AVIATION RESPONSE TO TWEED VALLEY HOSPITAL EIS FEEDBACK

1. The Environmental Impact Statement (EIS) for the Tweed Valley Hospital (TVH) invited feedback specifically relevant to the aviation discipline from the following:

ATTACHMENT 1: GCA RUNWAY 32 RNP APPROACH CHART

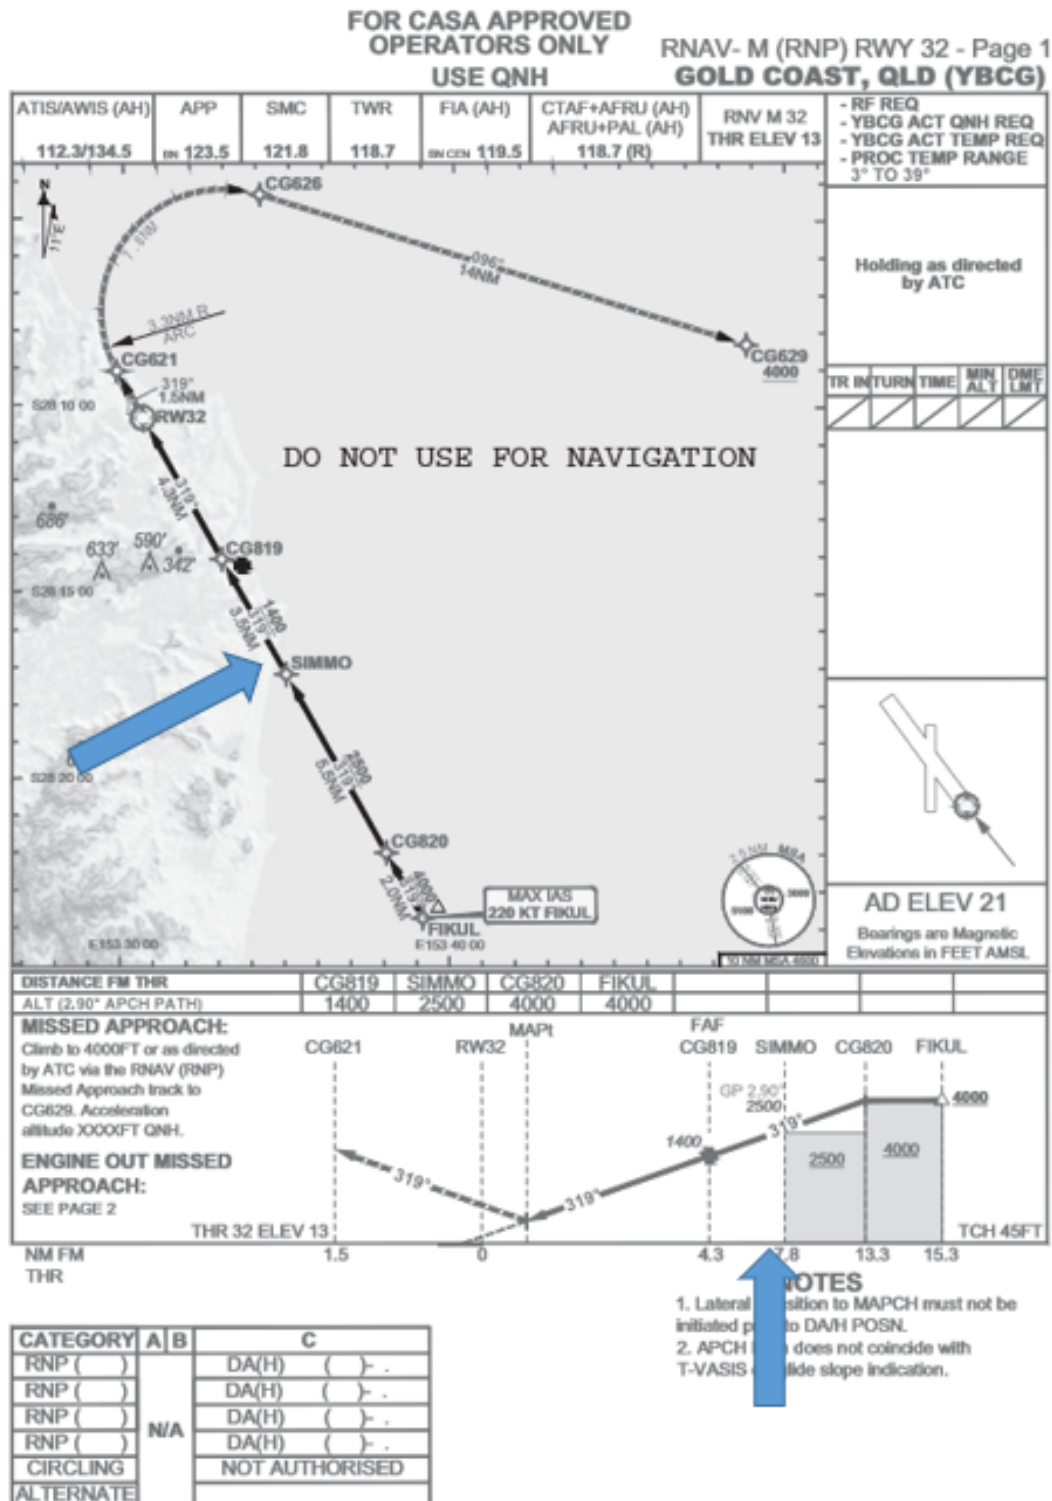
- a. AirServices Australia (AirServices),
 - b. the Civil Aviation Safety Authority (CASA) and
 - c. Gold Coast Airport (GCA) Pty Ltd.
2. The AirServices advice that TVH and its aviation operations will not adversely affect the smooth running of Gold Coast Airport is noted. The caveat related to "procedures not designed by AirServices at Gold Coast Airport were not considered in this report" pertains to Required Navigation Performance (RNP) Approach Charts developed mainly for Qantas by Naverus Inc, a wholly-owned subsidiary of General Electric Aviation. Although not "designed" by AirServices, the Naverus Inc RNP approaches are published by AirServices in Departure and Approach Procedures (DAP) for use by "CASA approved operators only". The minimum altitudes for the Naverus Inc approaches are consistent with other AirServices designed approaches into the Gold Coast airport i.e. overflight by commercial aircraft approaching Runway 32 will be in the vicinity of 2000 feet above helicopter operations at TVH and under positive Air Traffic Control. See Attachment 1. No action or amendment to previous advice is necessary as a result of the AirServices feedback.
